POTENTIAL NON-CONSERVATISM IN BUTTERFLY VALVE TORQUE PREDICTIONS UNDER COMPRESSIBLE FLOW CONDITIONS.

Vogtle Electric Generating Plant
10 CFR 21 Report
Electric Power Research Institute
Motor Operated Valve Performance Prediction Methodology
Versions 1.0 through 3.2

PPM Software Error Notice 2004-2 (Potential Non-Conservatism in Butterfly Valve Model Predictions under Compressible Flow Conditions)

Figure 2 (cont. on following pages)
Butterfly Valve Disc Shapes (shown to scale) Used in Compressible
Flow Tests Performed by Kalsi Engineering, Inc.

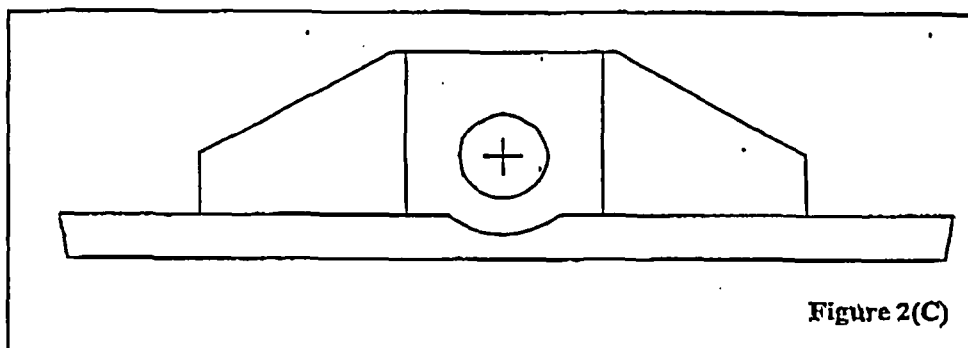
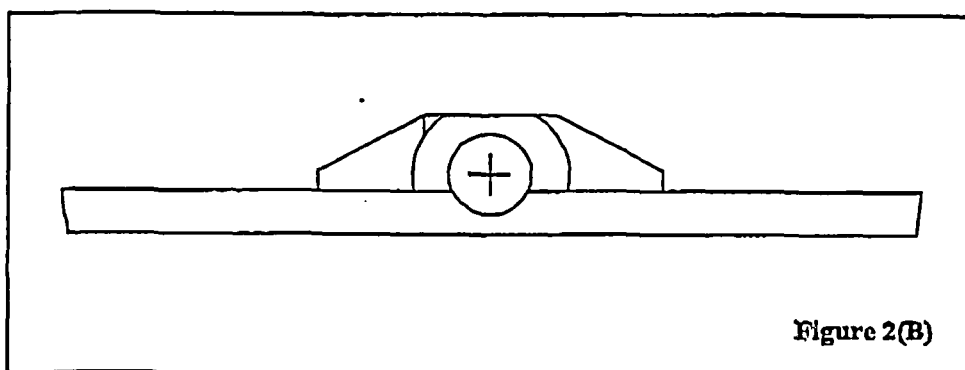
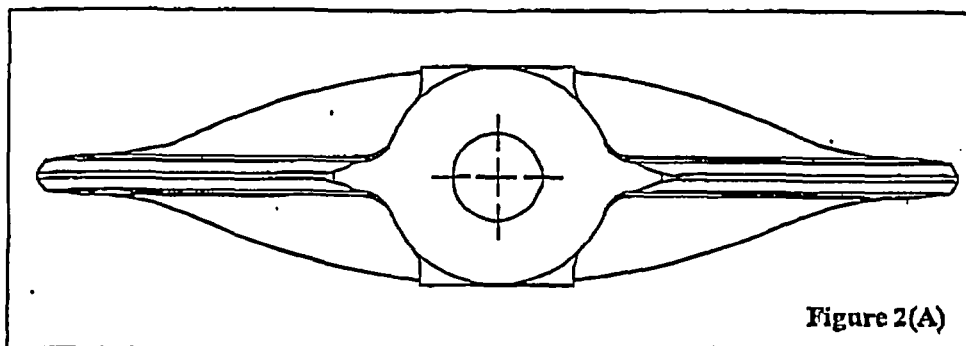
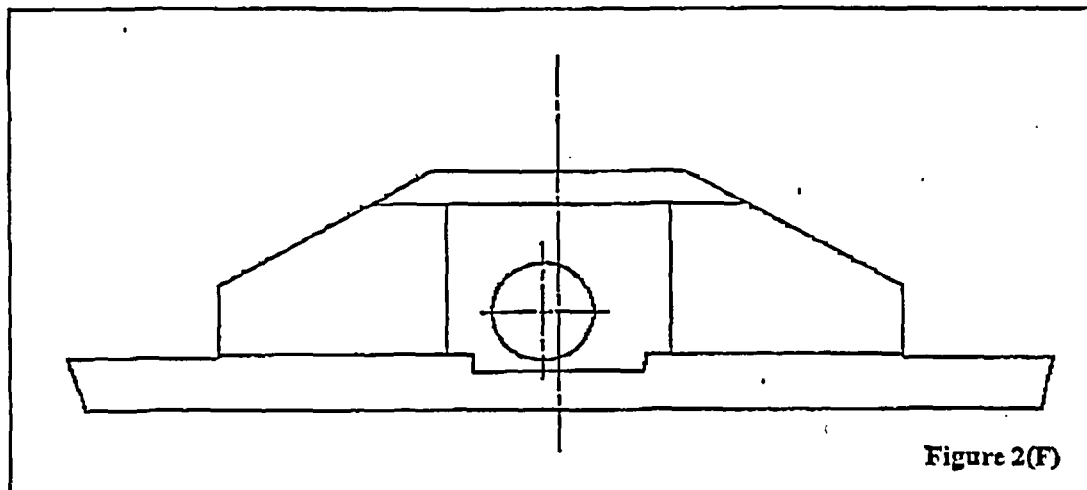
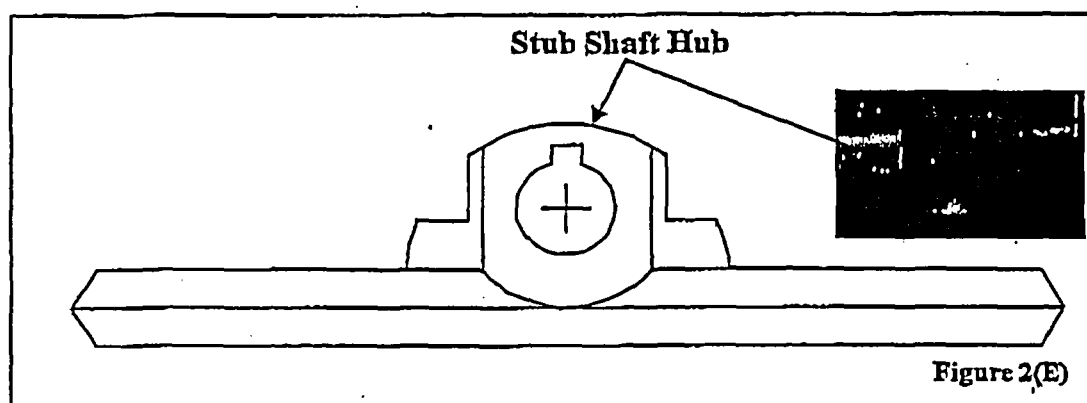
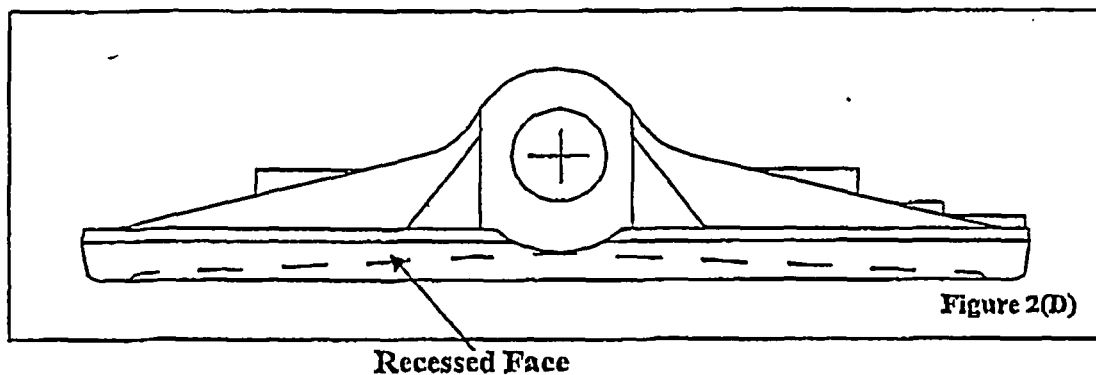
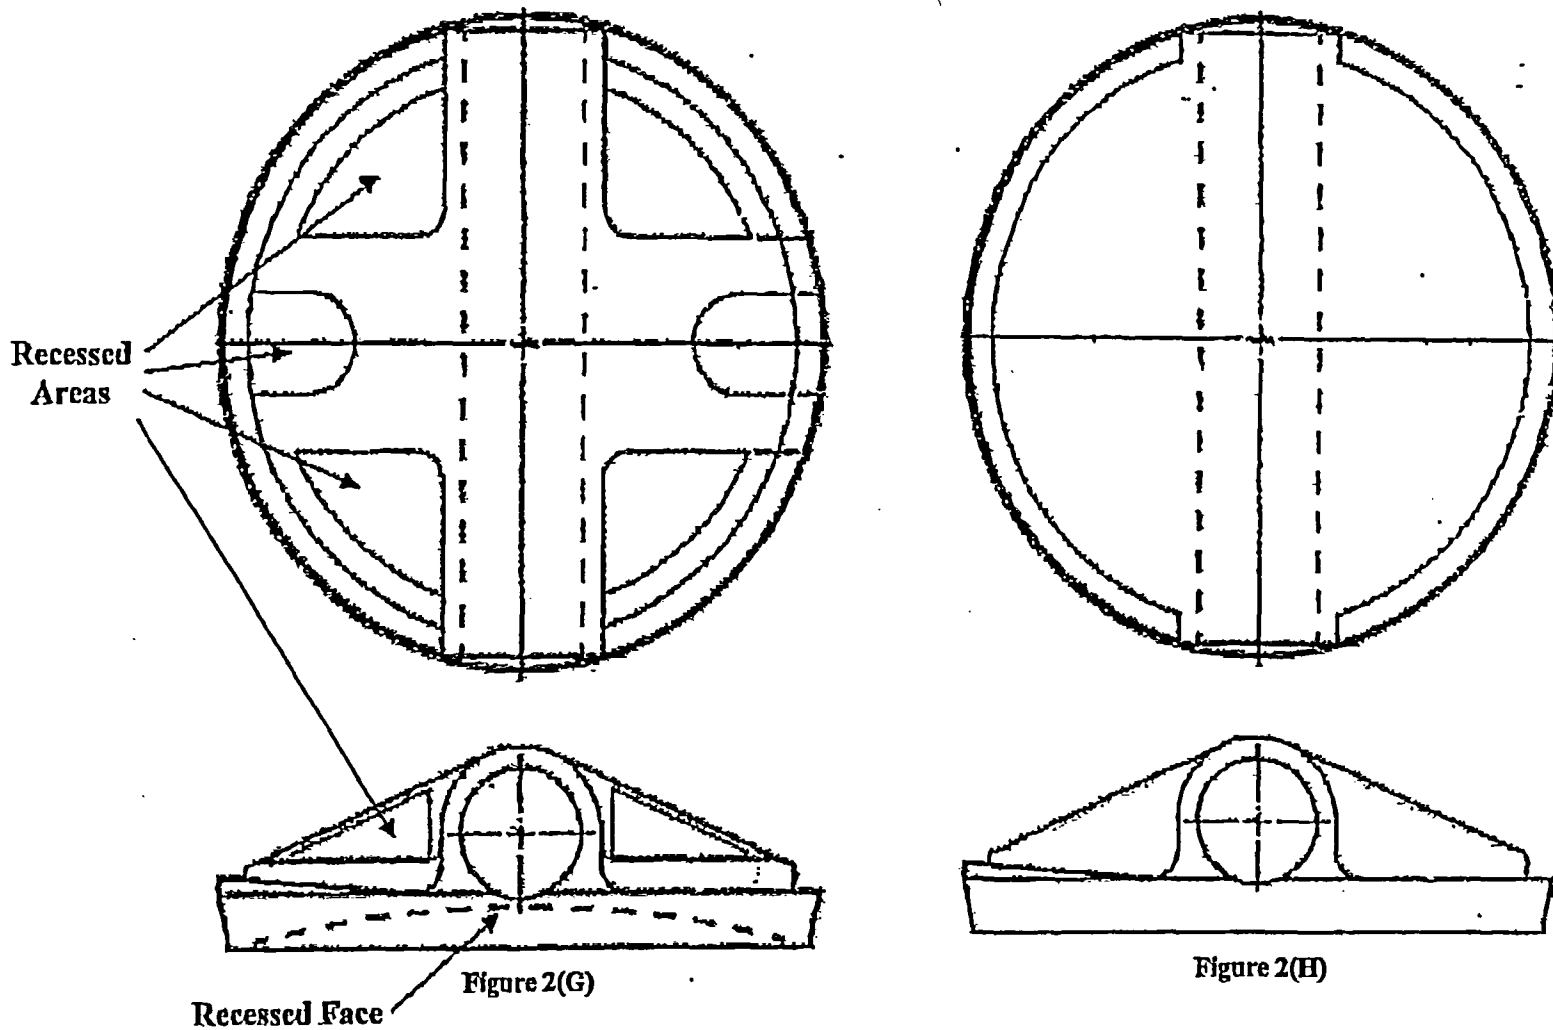
Comparisons completed to date show that under compressible flow conditions, the PPM butterfly valve predictions of maximum required hydrodynamic torque in the closing direction for the disc design shown in Figures 2(C) and 2(D) were found to be non-conservative by as much as 5 percent and 45 percent, respectively. The disc design shown in Figure 2(C) has similar geometric features to those tested by INEL. The disc design shown in Figure 2(D) is somewhat different than the INEL test valves disc shapes used to validate the PPM for compressible flow conditions, in that it has a shallow concave recess in the front face. The reported non-conservatism in hydrodynamic torque is based on limited comparisons between the PPM predictions and test data. Under compressible flow blowdown conditions, the hydrodynamic torque is the major component of the total required dynamic torque that is used for actuator sizing

Table 1 shows the applicability criteria for the PPM Butterfly Valve Model (Reference 1, page 7-24). The Table indicates applicable disk designs must have prismatic or conical back faces and flat front faces. The disk shown in Figure 2(C) is clearly applicable for PPM evaluations based on these criteria. The disk shown in Figure 2(D) has a shallow concave recess in the front face. Reference 2, page 2-1, under Terminology: Non-symmetric disk with single offset stem states, "The disk face away from the stem is typically flat or has a small curvature and is commonly referred to as the flat face". Based on this statement, the shallow concavity of the disc shown in Figure 2 (D) can be interpreted to be within the applicability of the PPM. Table 1 also indicates that the disc must have a prismatic or conical back face. The disc shown Figure 2(D) has features that could be interpreted as being prismatic and therefore within the applicability of the PPM.

1. Pending further EPRI evaluation, for butterfly valves with non-symmetric discs with the shaft in the downstream orientation, in compressible flow applications and in the closing direction, use of the PPM Butterfly Valve Model should be restricted to valves with a completely flat front face, e.g., the PPM butterfly model shall not be applied to butterfly valves with a recessed (curved or flat) front face.

1. For butterfly valves with non-symmetric discs with the shaft in the downstream orientation, in compressible flow applications and in the closing direction, meeting all PPM applicability requirements and accounting for the restriction described above, the predicted maximum required total dynamic torque shall be multiplied by 1.05.

- If the front face is recessed, the user should evaluate the potential impact of a 45 percent increase in the maximum total required dynamic torque prediction.
- If the front face is truly flat and is not recessed, the user should evaluate the potential impact of a 5 percent increase in the maximum total required dynamic torque prediction.
